## 111864 - 00

**Change Notification #:** 111864 - 00  
**Change Title:** Intel® Desktop Board D2500CC, Bulk SKU: BLKD2500CCE  
PCN 111864-00, Product Material  
Replace Clock Generator  
**Date of Publication:** November 08, 2012

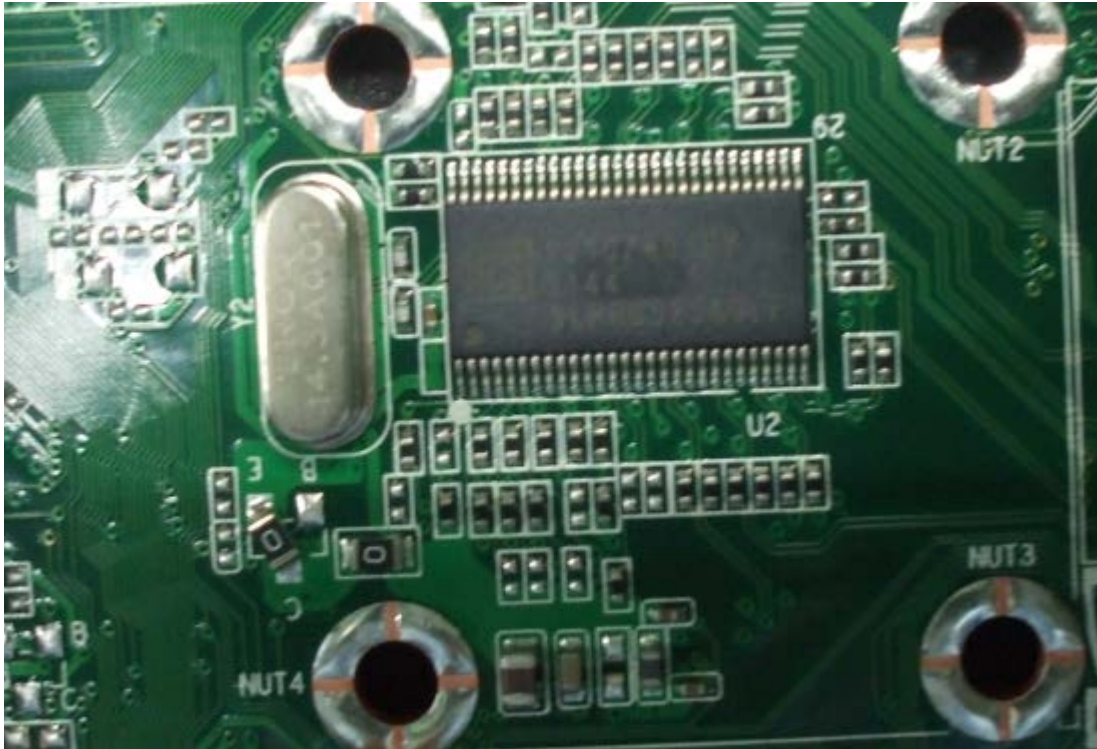
The clock generator chip will be changed from Silego (SLG505YC256CTTR) to IDT (9LPRS525AGLFT) in order to improve supply availability. There will be a change to some supporting components associated with the clock generator (remove R249, C111, R486 and Q21 and add 0 ohm on R486 and Q21).

Before

After
